Implementation of V-Lock cord retaining feature as standard.

Product Change Notification					PCN 5150 with V-Lock			
owner	creation date	release date	released by	change order no	rev	page	D10-006-439	
ismailbe	2016-07-06	2017-01-20	blumhe	2011286	Α	1 of 2

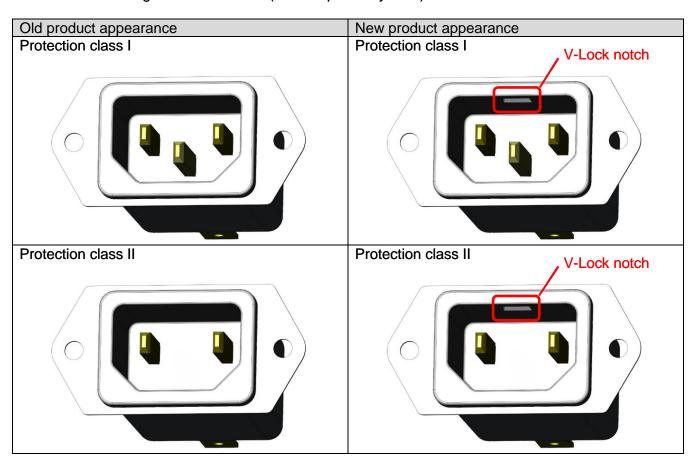
V-Lock feature integrated as standard (not an option anymore)

Form Yes Socket has notch for V-Lock cord Fit No There are no dimensional changes
